**THFC Hotel S73 Application – Wind Microclimate Review**

**Northumberland Development Project – Section 73 Application  
Wind Microclimate ES Addendum Review**

Figure 1 – Mean wind speed and turbulence profiles, all wind directions, 22.5-degree increments.

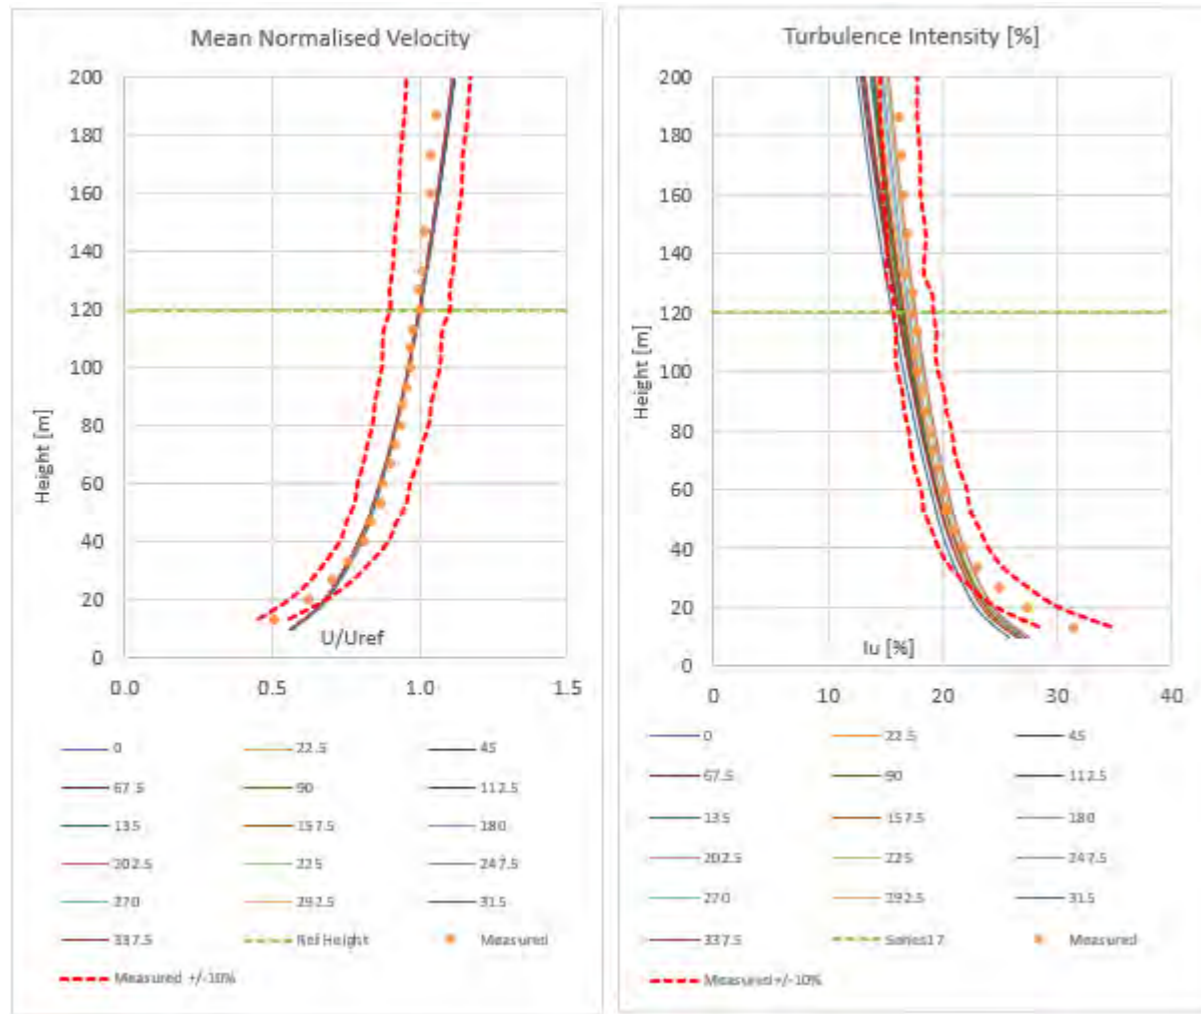
assessments, but the details of the assumed terrain and applied methodology provided is adequate to conclude that the approach is acceptable. However, the target profile for the atmospheric boundary layer simulation presented in Figure B.1 of Appendix 16.1 appears to be for 337.5°, which is unlikely to represent a critical wind direction. **It is therefore recommended that the applicant provides further details of the atmospheric boundary layer simulation used, including the upper and lower bounds on the profiles for the full range of wind directions, against the profile simulated.**

The changes to the landscaping to the north of the Plot 3 Hotel are addressed within the recently prepared ES Addendum Update Note. This specifically addresses the removal of a planter from north-western corner of podium terrace, which while present within the design for the July 2023 ES Addendum, was removed from the final submitted Section 73 application planning drawings, given the impact on available space for tables and chairs. This being the case, the terrace will be remain suitable for access and passage. The area of seating by the northern façade will be suitable for long-term sitting during summer and autumn, representing a negligible residual effect. Elsewhere with the removal of the planter, conditions are expected to meet the threshold wind speed for long-term sitting 80-90% of the time, depending on location. This represents a moderate adverse residual effect.
It is recommended that the applicant provides further details of the atmospheric boundary layer simulation used, including the upper and lower bounds on the profiles for the full range of wind directions, against the profile simulated.	The target profile for the atmospheric boundary layer simulation presented in Figure B.1 of Appendix 16.1 appears to be for 337.5°, which is unlikely to represent a critical wind direction.	Please see Figure 1 for a full suite of directional profiles.  The range of wind speed and turbulence profiles across all angles are sufficiently similar that they can be represented by a single wind tunnel profile. The selected angle is considered to be representative, with all profiles being reasonably represented by the measured wind tunnel profile up to and just beyond the reference height. At the lower end of the height range, where the agreement falls away, the profile will be corrected by the detailed proximity model.

Figure 3 – Dare Skywalk, CFD predictions of summertime comfort.

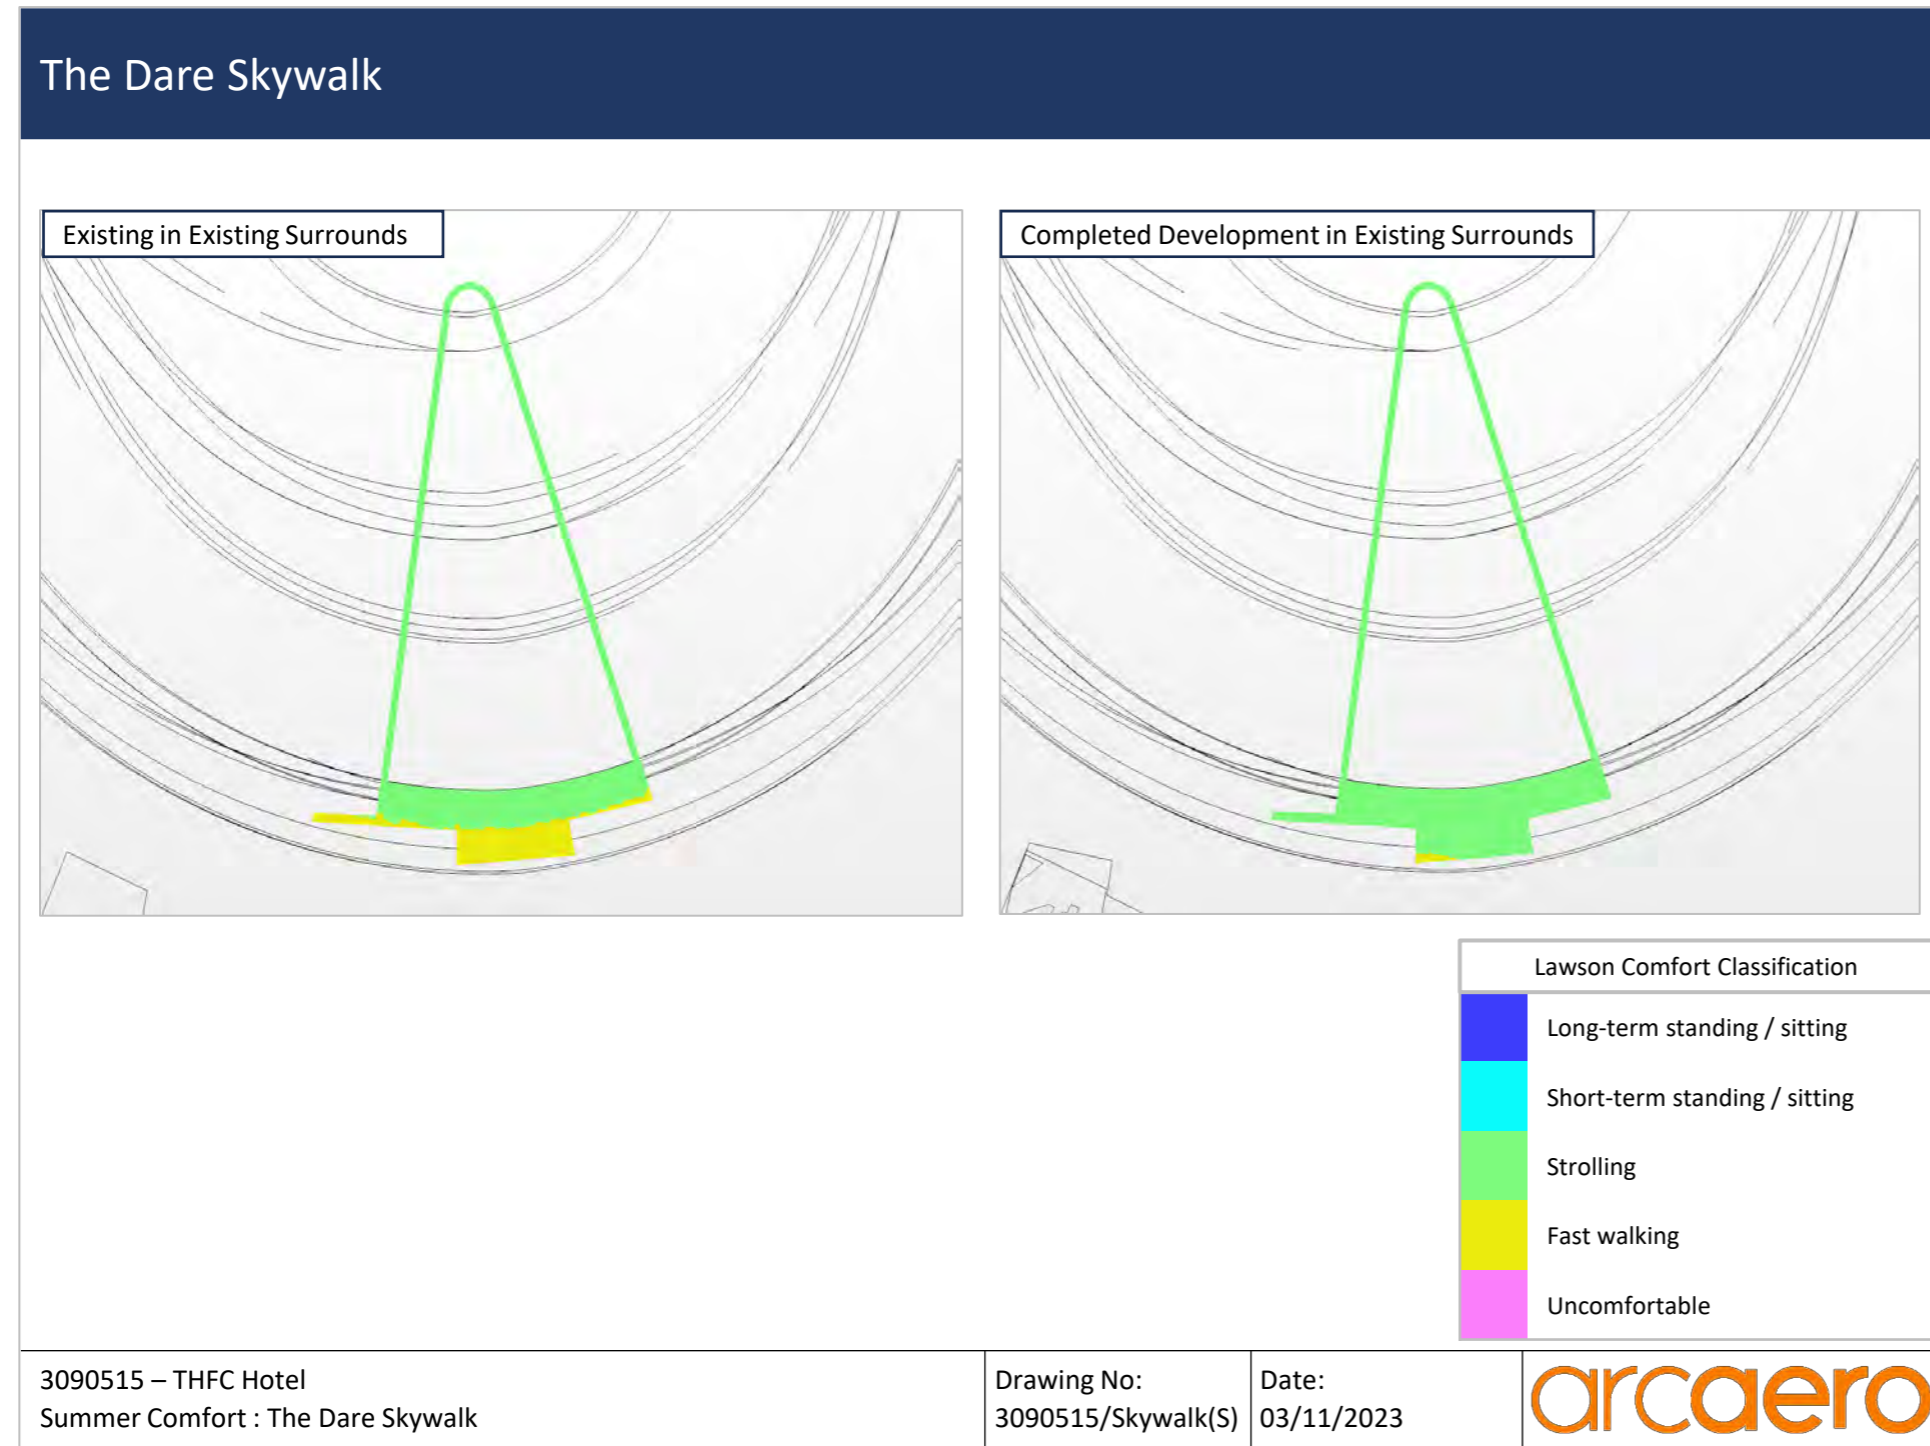
- The Dare Skywalk;
- Podium level entrances and potential cafe outdoor seating for the Tottenham Experience;
- The playground of St Francis de Sales Junior School; and
- Commercial and residential entrances and private gardens along Park Lane.

The response indicates that summer conditions are expected to be suitable for a mix of leisurely strolling and fast / business walking for baseline conditions, with the area suitable for only for fast / business walking reduced for proposed site conditions. The effect of the proposed Development is therefore stated as minor beneficial. This conclusion is considered plausible, though based on the significance criteria outlined in the ES Addendum this would perhaps more appropriately be stated as negligible. It should also be noted that we have not been able to identify the exact route of the Skywalk or the seasonal usage and so assume that the relevant information has been provided to the applicant's consultant and applied accordingly.

Figure 4 – Tottenham Hotspur Experience, CFD predictions of worst-seasonal and summertime comfort.

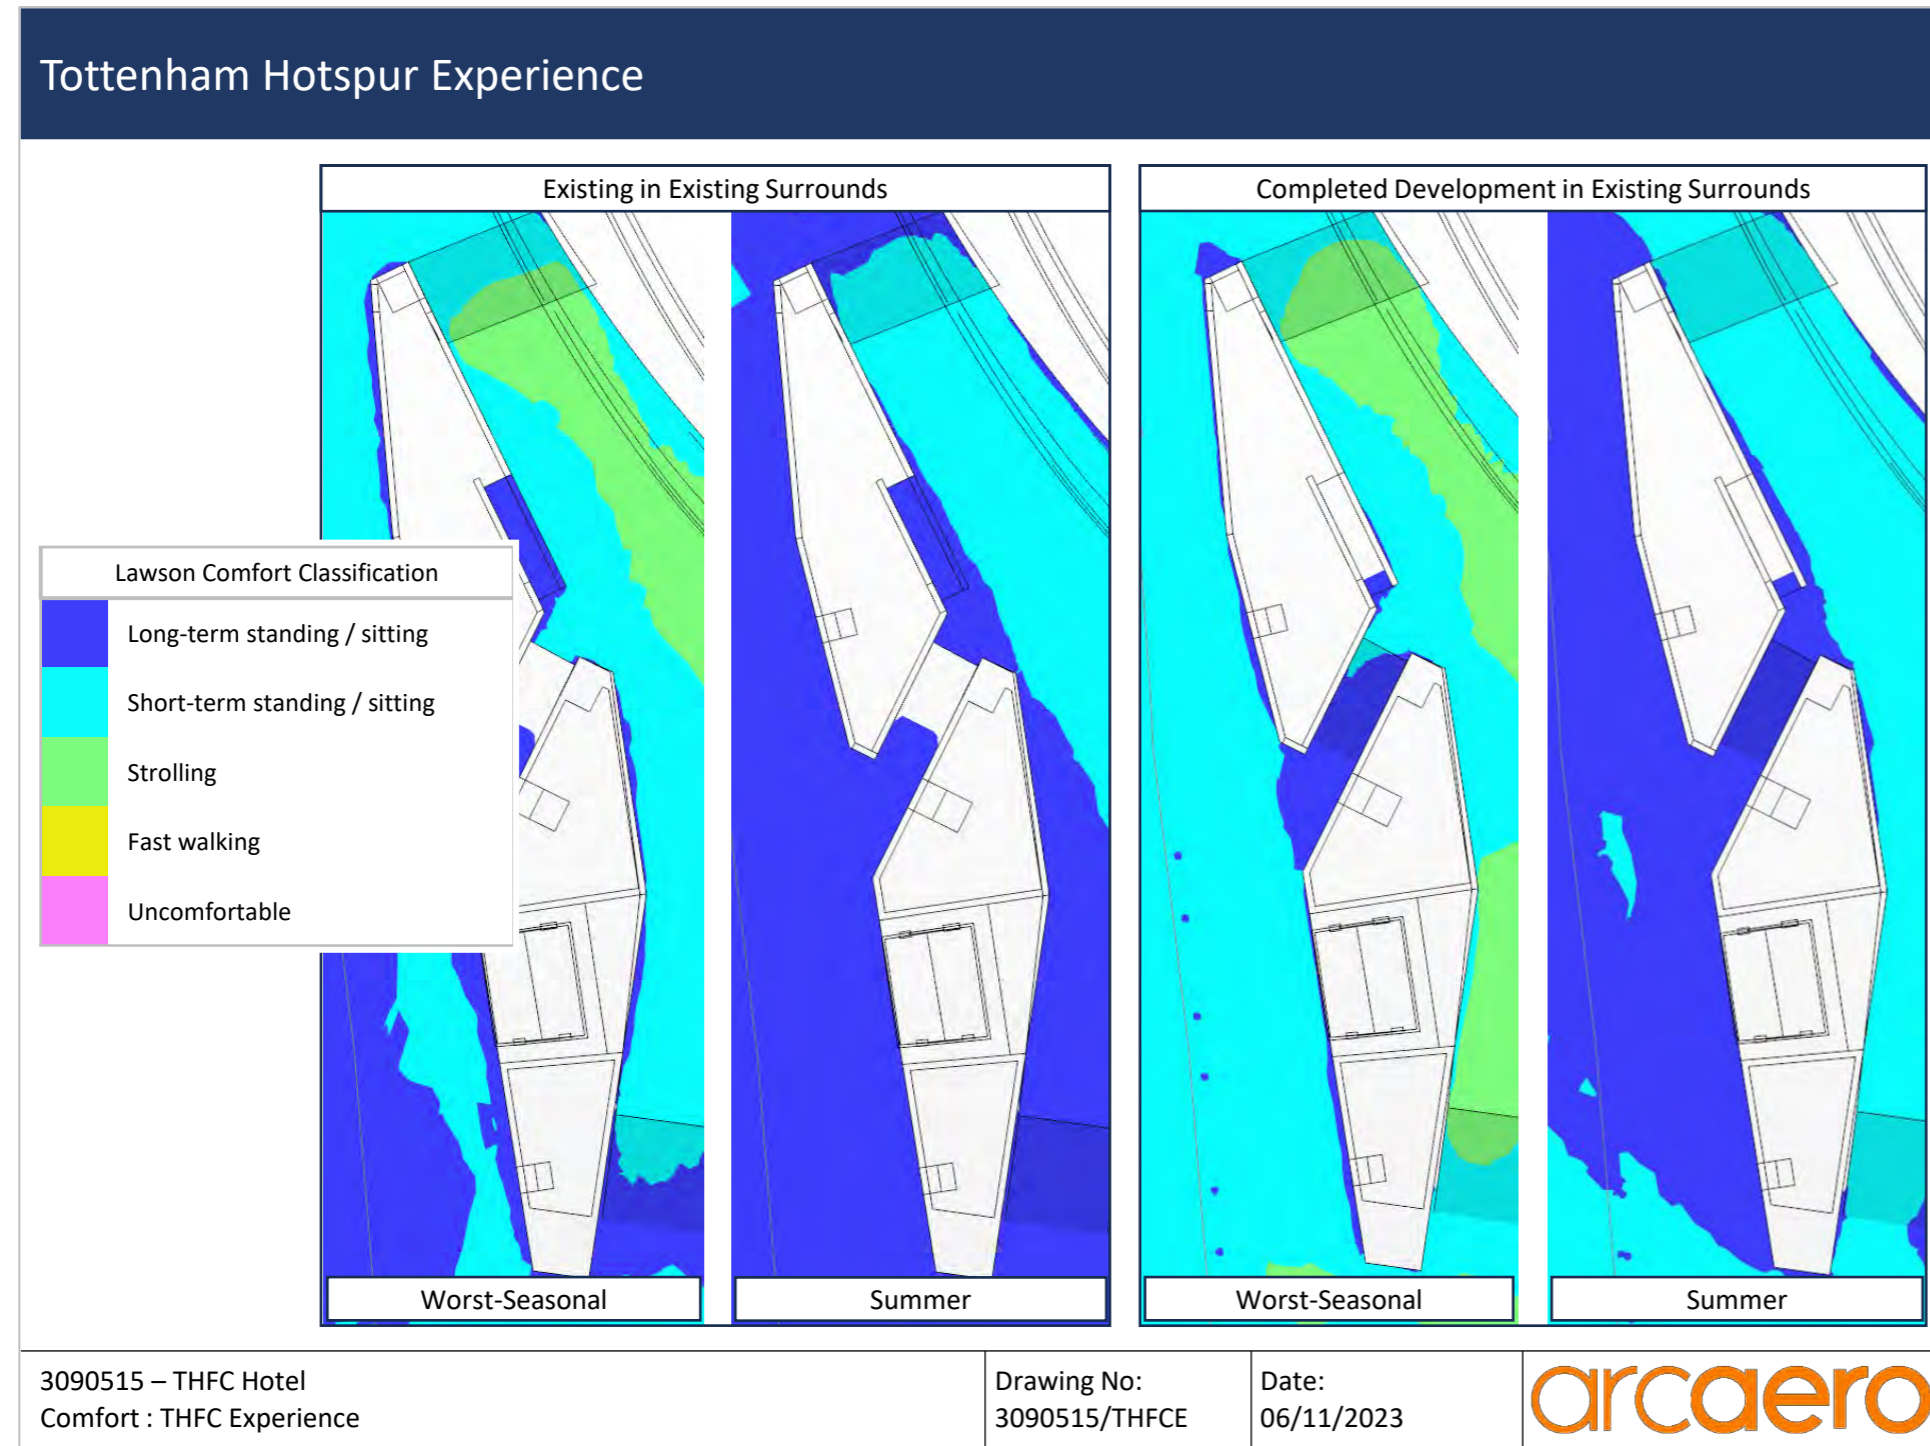
The response regarding the potential café outdoor seating considers a roof area, rather than the podium-level area requested (and shown in the wider landscaping plans). The presented podium-level results appear to suggest that baseline conditions may be suitable for outdoor seating in summer but that with the introduction of the proposed Development conditions may become too windy for such uses. **It is recommended that further clarification be requested on this.**

<p>Podium level entrances and potential cafe outdoor seating for the Tottenham Experience</p>	<p>Please see Figures 4 &amp; 5 that present CFD contours for the Plot 4 Tottenham Hotspur Experience.</p> <p>Entrance conditions are suitable for short-term standing / sitting in the worst season and are suitable for ingress / egress. This includes the entrance to the Dare Skywalk reception (the northernmost entrance) which is recessed behind the building line. This represents a negligible effect.</p> <p>It is understood that potential café seating refers to the roof to the north of Warmington House. The wind conditions here and in the occasional event space rooftop further north are predicted to remain suitable for short-term standing in the worst season and for long-term sitting in summer.</p>
	<p>The playground of St Francis de Sales Junior School</p>	<p>Please see Figure 6 that presents worst-seasonal CFD comfort contours for the school playground for the completed Development.</p> <p>Conditions are suitable for a mixture of short-term and long-term standing / sitting throughout the year and are correspondingly suitable for a general / active recreational area such as a school playground. Relative to the baseline scenario, the suitability of the playground is materially the same. This represents a negligible effect of the Completed Development.</p>
